MODEL OR MODULE AFFECTED
M5 MARKER ADDER MODULE ON PC BOARD

NATURE AND REASON FOR CHANGE TO HELP ELIMINATE MODULES SENSITIVITY TO VARIOUS MECHANICAL AND ELECTRICAL PROBLEMS.

SHEET 282

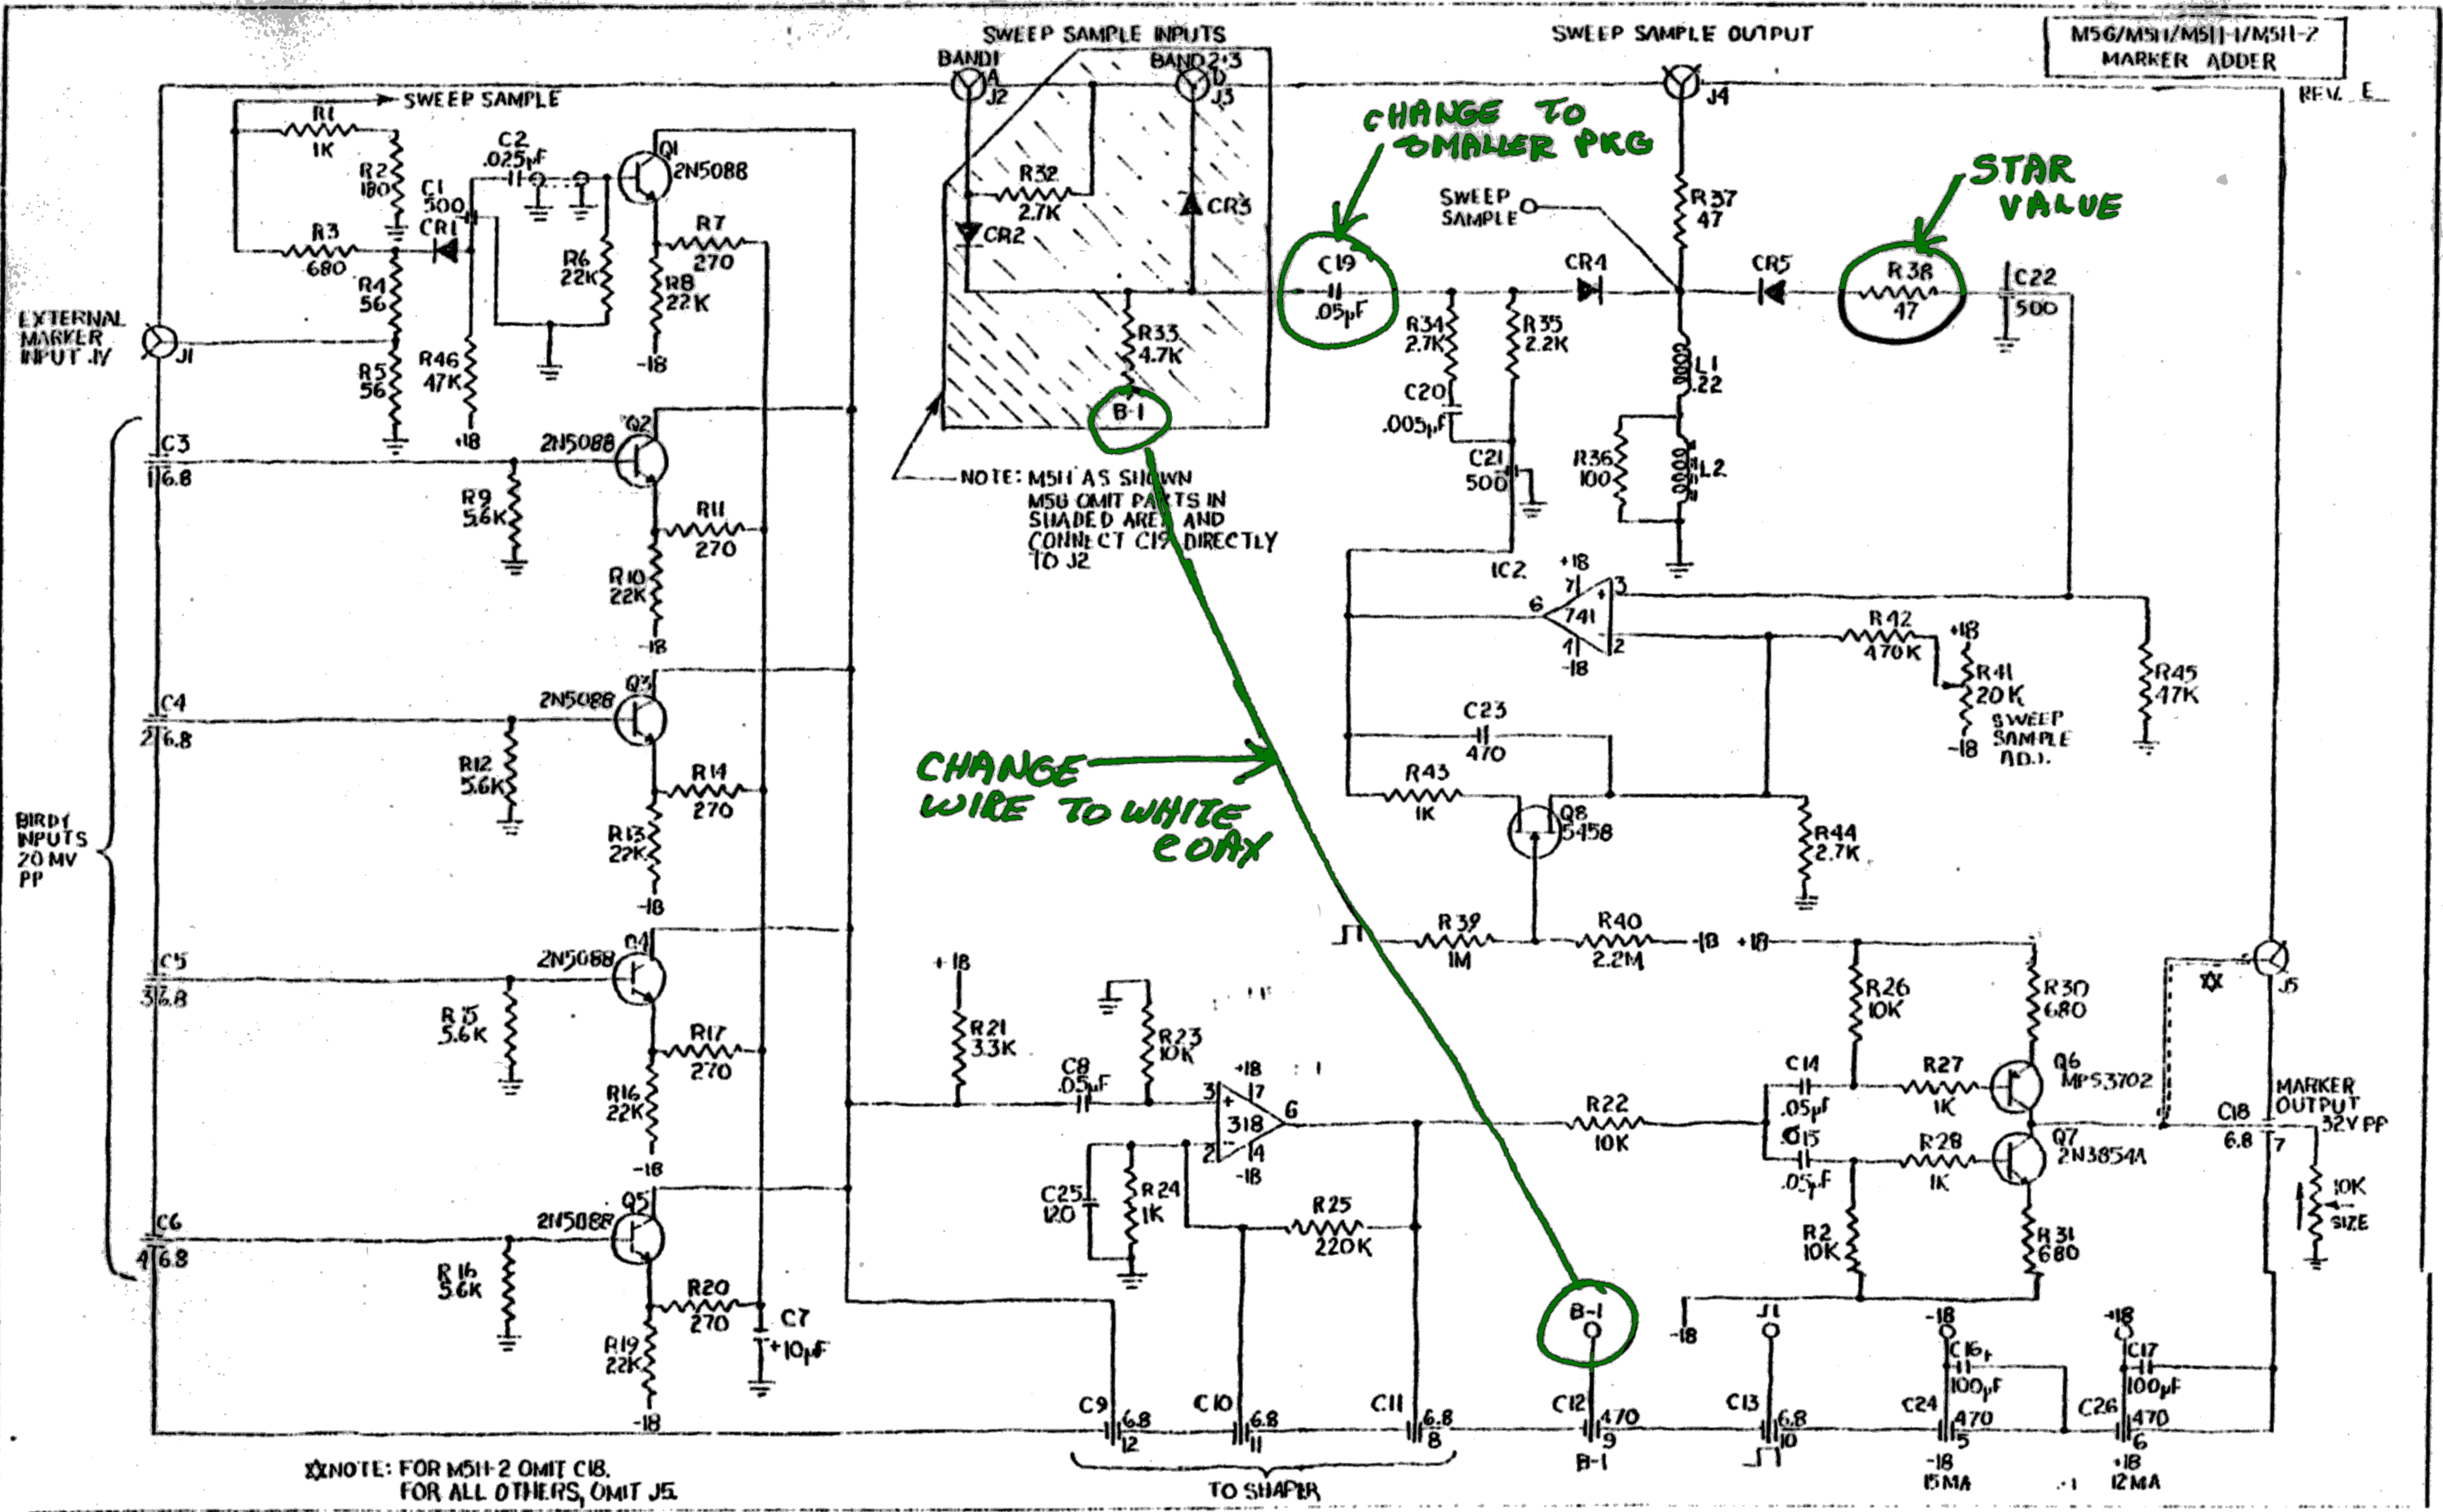
1. CHANGE WIRE FROM PIN 9 TO R33 (PIN DIODE SWITCHING) FROM STANDARD WIRE TO WHITE COAX. THIS ELIMINATES THE WIRE ACTING AS AN ANTENNA

2. CHANGE C19 TO A DIFFERENT PACKAGE TYPE (SMALLER) PHYSICAL SIZE

3. HAVE GROUND PLANE OF PC BOARD SOLDERED ALL AROUND THE WRAP AROUND.

4. MAKE R33 A STAR VALUE TO ALLOW SWEEP SAMPLE FLATNESS COMPENSATION

*Sweep Sample Unit on PCB
 Add solder on top of cone over 47 capacitor*

SOLDER PC GROUND PLANE
 COMPLETELY TO WRAP AROUND
